OJAI UNIFIED SCHOOL DISTRICT

BID ADDENDUM NO. 2 ISSUED 4/8/2019

**LIBRARY REMODEL
AT NORDHOFF HIGH SCHOOL
PROJECT NO. 2018-1714**

A-402

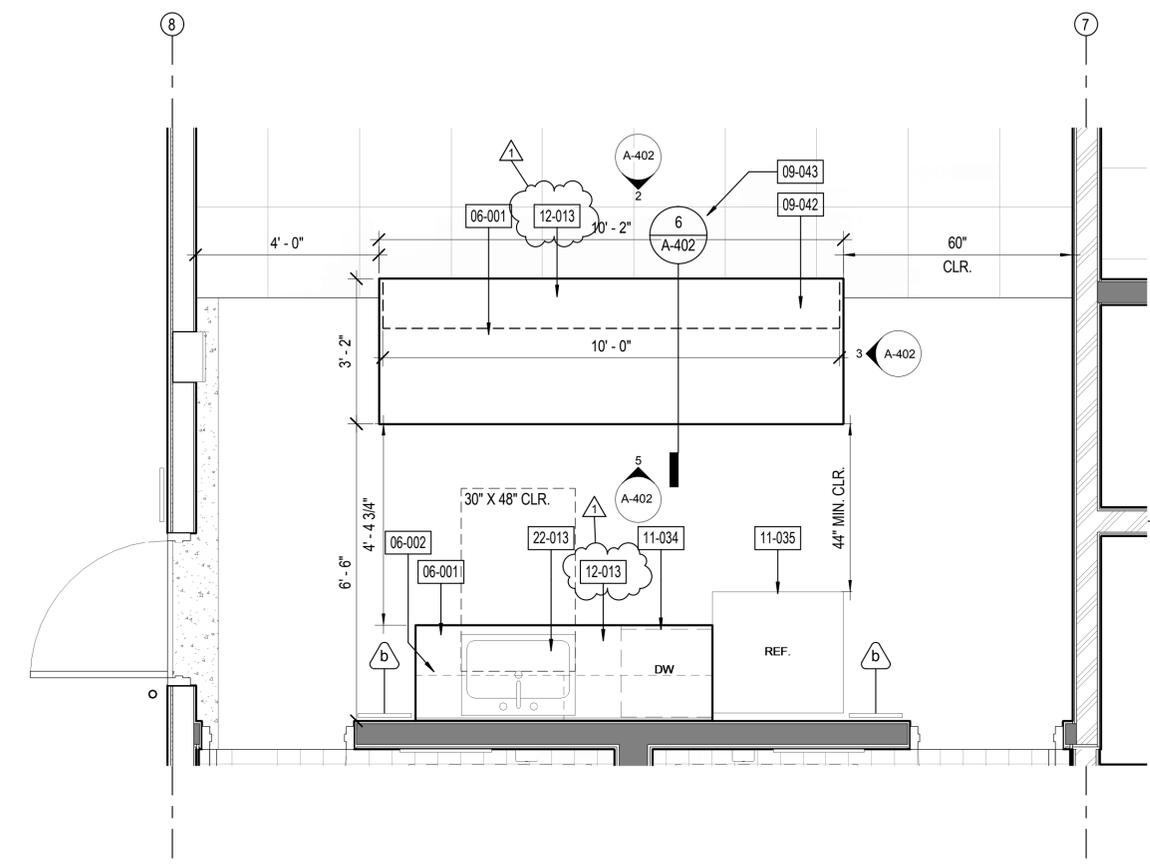
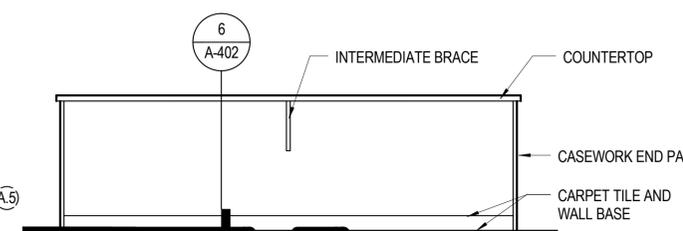
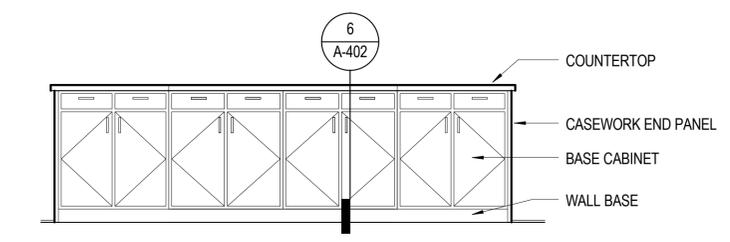
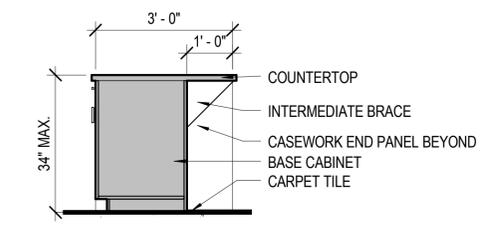
Item 2 **A-401 and A-402 Enlarged Plans** – Keynote 12-014 revised to be 12-013.

oversight from third party arborist under contract with the District. a) The cost of the arborist is to be paid by the owner. The arborist will not be under contract with the Contractor. b) The Post Construction annual monitoring is to be facilitated and paid by the owner.
8	Sheets A-401 & A-402 included a Keynote 12-014, which seems to point to countertops. Keynote 12-014 in the Keynote Legend is blank and does not have a description. Please clarify this.	Keynote 12-014 corrected to be 12-013 referencing plastic laminate countertops. Enlarged Plan sheets A-401 and A-402 revised and included in Bid Addendum 02.

| 12-013 | PLASTIC LAMINATE COUNTERTOP |
